10GHz CBNL VS2 TRX BOARD MODIFICATION

YO4HFU - 01.04.2023, rev.1

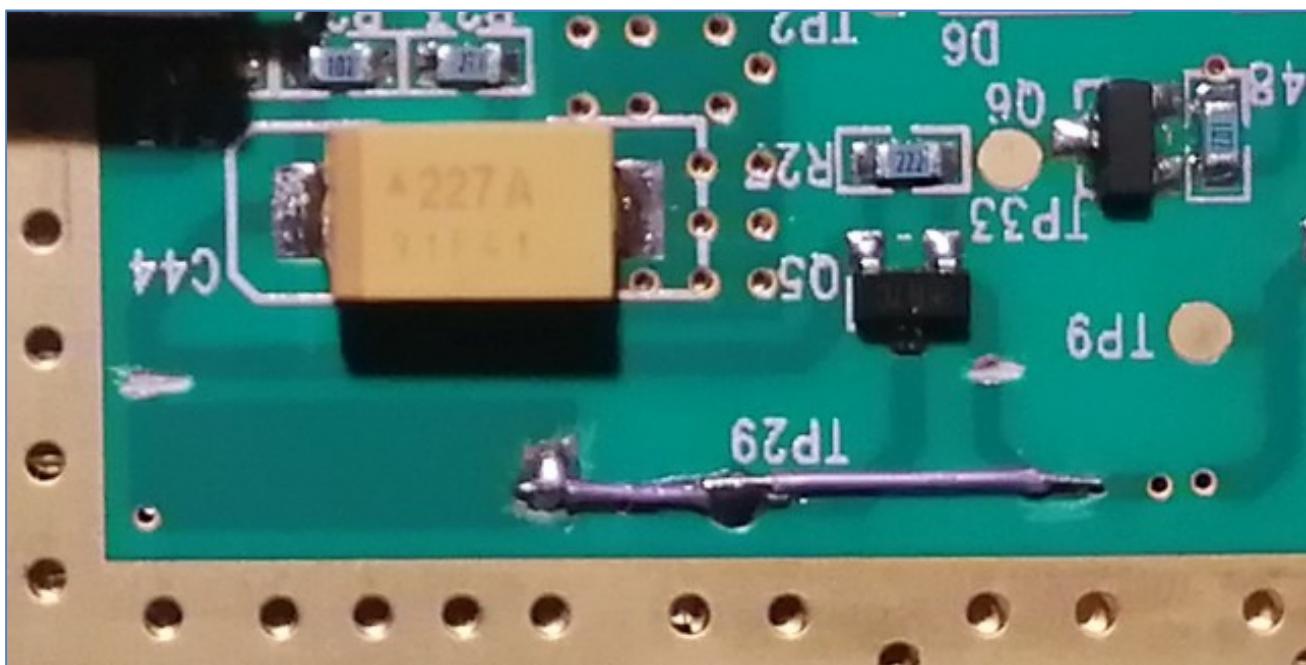
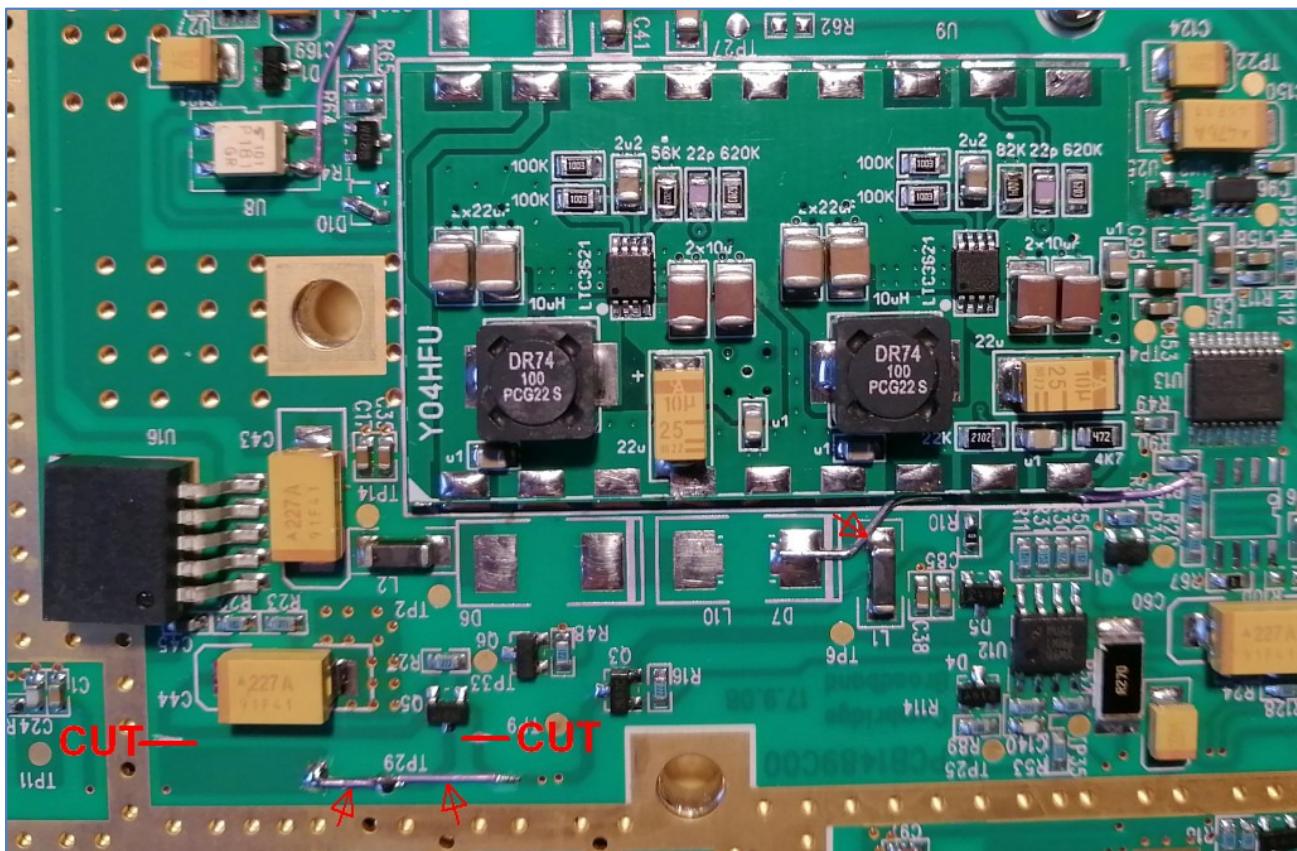
- Install new PSU PCB
- Remove D7 and D9. To reduce voltage drop/dissipation, PA stage will be supplied directly by stable +5V TX.
- Cut next traces according bellow image. Solder jumpers between TP29 and already cut traces. Modification is required to supply U7 & U21 MMIC only during TX.
- Solder jumper between PSU pin 7 (TX +5Vout) and D7 or L1.
- Solder jumper between R90 (1K) terminal and PSU pin 9. Signal used as TX control of PSU.

Before and after CBNL TRX modification:

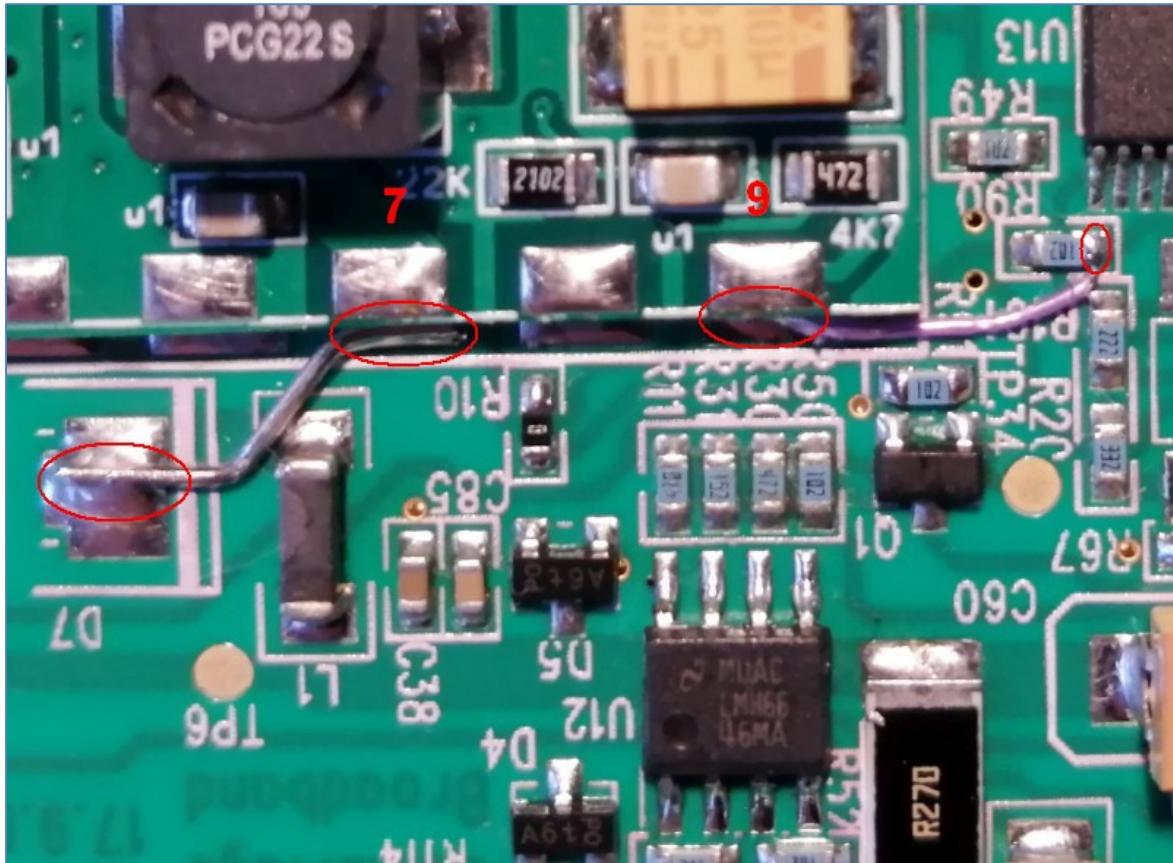
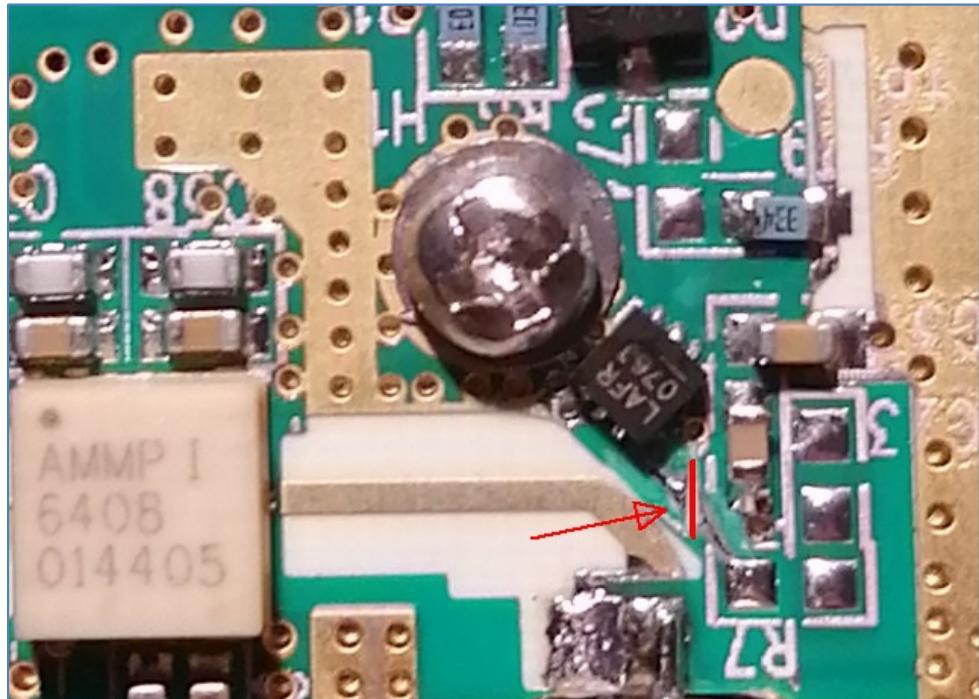
- Half cut of RF pickup line, pin 6 LTC5532. Modification required to avoiding RF detector saturation (max. 4.4V out)
